Delegated Report		Analysis sheet		Expiry Date:	20/12/20	021	
		N/A / attached		Consultation Expiry Date:	26/12/2021		
Officer		Application Number(s)					
Obote Hope			2021/5201/P	2021/5201/P			
Application Address			Drawing Numb	Drawing Numbers			
83 Lawn Road London NW3 2XB				See decision notice			
PO 3/4 Area Tea	m Signature	C&UD	Authorised Off	icer Signatu	re		
D							
Proposal(s)							
Erection of single storey rear extension.							
Recommendation(s):	Refuse planning permission						
Application Type:	Householder Application						
Conditions or Reasons for Refusal:	Refer to Decision Notice						
Informatives:							
Consultations							
Adjoining Occupiers:			No. of responses	<b>00</b> No. 0	f objections	00	
	A site notice was displayed on 01/12/2021 expiring 25/12/2021.						
Summary of consultation responses:	The application was also publicised in the local press from 02/12/2021 to						
CAAC	<ul> <li>The Belsize CAAC have objected on the following grounds:</li> <li>The floor area of the proposed extension is excessive and unjustified</li> <li>existing bay window should be retained and the garden room enlarged no more than the neighbours extension.</li> </ul>

## 1. Propo

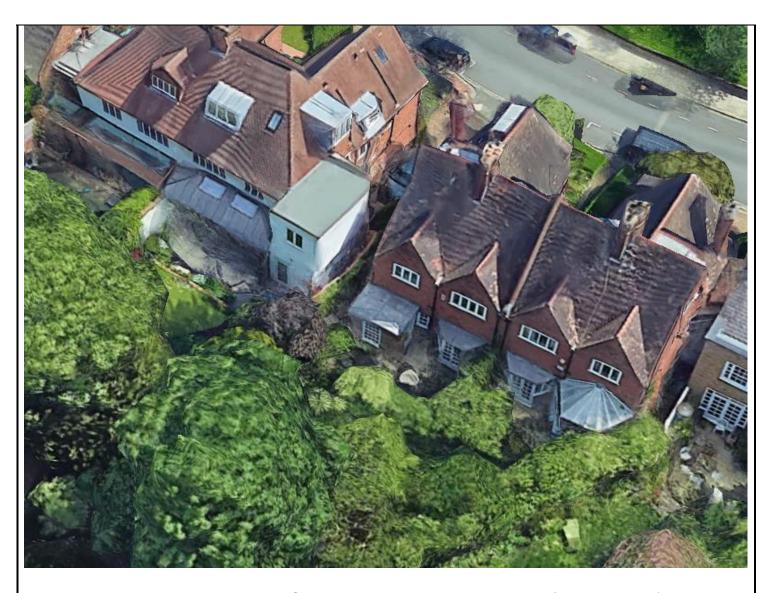
- 3.2. In this instance, the rear of the host building forms a relatively harmonious pair with no 84 and the distinctive ground floor bay window which is retained on both properties, contributes to the harmony. The demolition of the existing bay window and erection of a full width rear extension would disrupt the pattern of development, including the proportion of built to unbuilt space, which is relatively uniform across the pair. Along the southern end of Lawn Road, these two properties are the only pair to retain their bay windows and the distinctive rear bays are fully appreciated.

- 3.6 The proposal has failed to take under consideration the group value, context and the setting of buildings, as well as their quality as individual structures and any contribution to the setting of the semi-detached pair. The proposed design would compromise the architectural character of the host building. Its detailing would not respect the character of the rest of the property and the height increase of 1m along the full-width of the rear elevation would further detract from the

uniformity of the semi-detached pair. Whilst the revision changes the fenestration treatment to include three timber framed French doors this would not compensate for the loss of the bay window.

- 3.9.1 In conclusion, the proposed extension, owing to its width and the loss of the ground floor bay window feature, as well as its detailed design, is considered to be harmful to the character and appearance of the host property and its relationship with its neighbour No. 84 to which it forms a part of.

5.1 Refuse Planning Consent
